## Official Notification - Federal Boat Safety Act Sport Jet 90

### 1993 and 1994 SPORT JET 90

#### LOCKING TAB - SHIFT CABLE CLAMP

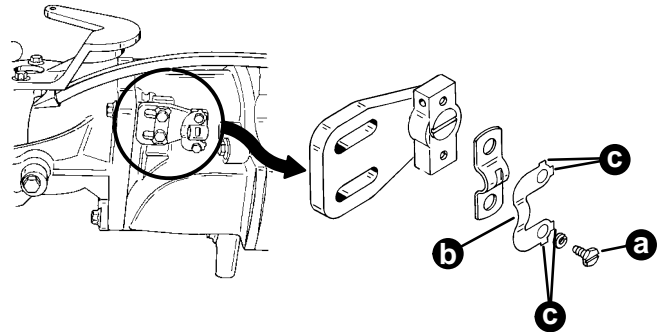
We have some reports of the shift cable clamp screws loosening. This condition can result in loss of shift control.

1. Install a tab lock, p/n 14-820601, as shown in the figure below with radius portion (b) of the tab lock towards the reverse gate.
2. Torque screws (a) to 50 lb. in. (5.65 N-m).
3. Bend tabs (c) over flats of the screw head.

a - Screw (2)  
b - Tab Lock- Positioned Toward Reverse Gate  
c - Locking Tabs

#### PIVOT BOLT - REVERSE GATE

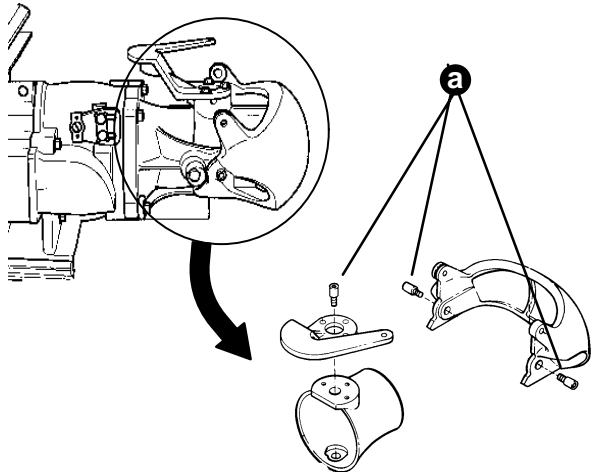
Loose reverse gate pivot bolts have been reported on some pumps. This condition can lead to loss of shift control.

1. Remove three pivot bolts (a) as shown in the figure following.

- Apply Loctite #271 (p/n 92-32609-1) to threads of the pivot bolts.
- Install pivot bolts (a) and torque to 25 lb. ft. (33.89 N·m).

a - Pivot Bolts (3)

**GROUP #3  
BOOT - STARTER SOLENOID**

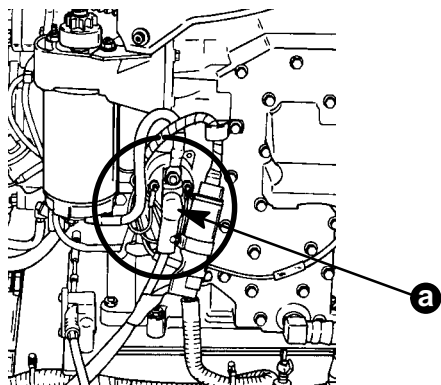
The U.S. Coast Guard recently cited two boat builders who were in violation of regulation #33 CFR 183.445 (b) which requires that the “positive” battery cable connection at the starter solenoid terminal be protected by either a boot (a) or protective shield.

a - Boot, Positive Battery Terminal

For the convenience of all parties (the consumer, dealer and boat builder), inspect the starter solenoid terminal connection with the “positive” battery cable to see if it is protected with a boot. If it is not, order the boot (p/n 85-79695) and install on the terminal connection of the “positive” battery cable and terminal of the starter solenoid.
